WE2.032 Rev. 1

Gunite Automatic Slack Adjusters

Subject: Engineering change to eliminate cotter pins

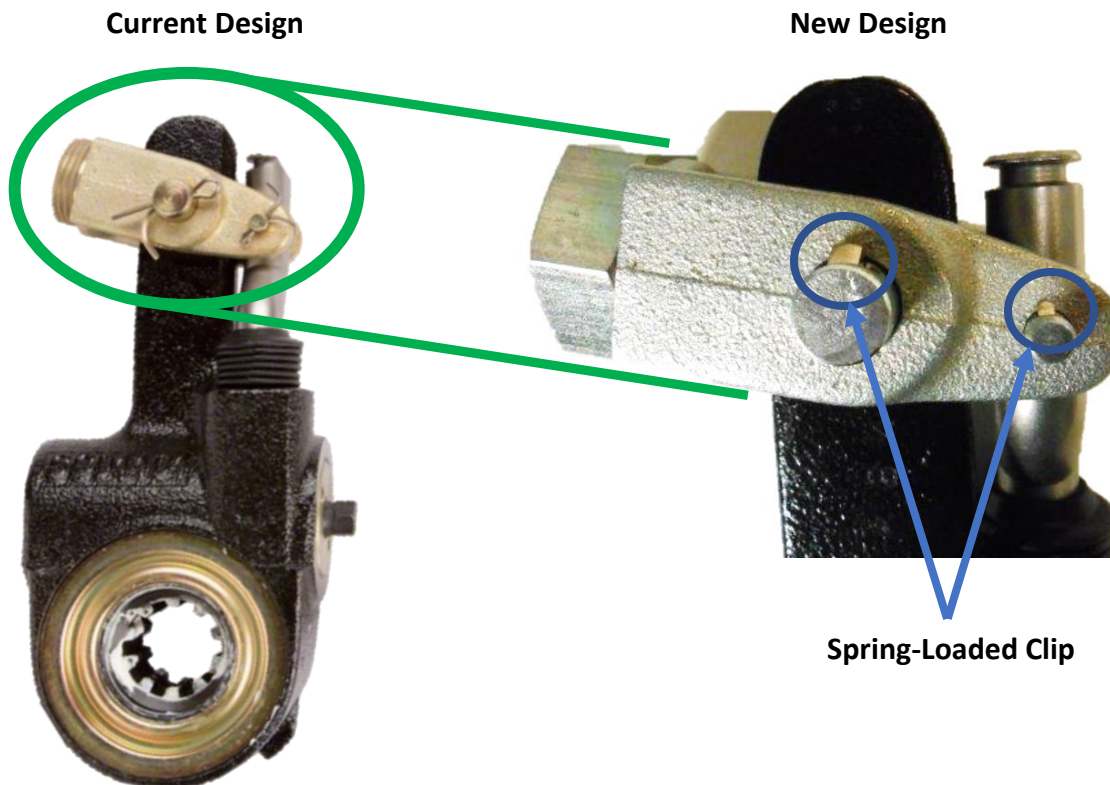
The Gunite automatic slack adjusters will undergo an engineering change to improve assembly and disassembly with the clevis body. The new design features pins with an integrated spring-loaded clip, as opposed to the cotter pin design that previously held the pins in place. The new pins snap in place with no additional operations and are removed by pushing in the spring-loaded clip and removing the pins.

Starting September 4, 2019, the SA10802 and SA10803 part numbers will be changed to the new pin. All other Gunite Slack Adjuster assemblies will be changed before the end of 2019. Service kits will retain the old cotter pin design until inventory is depleted. The new pin design is interchangeable with the old design in all applications.
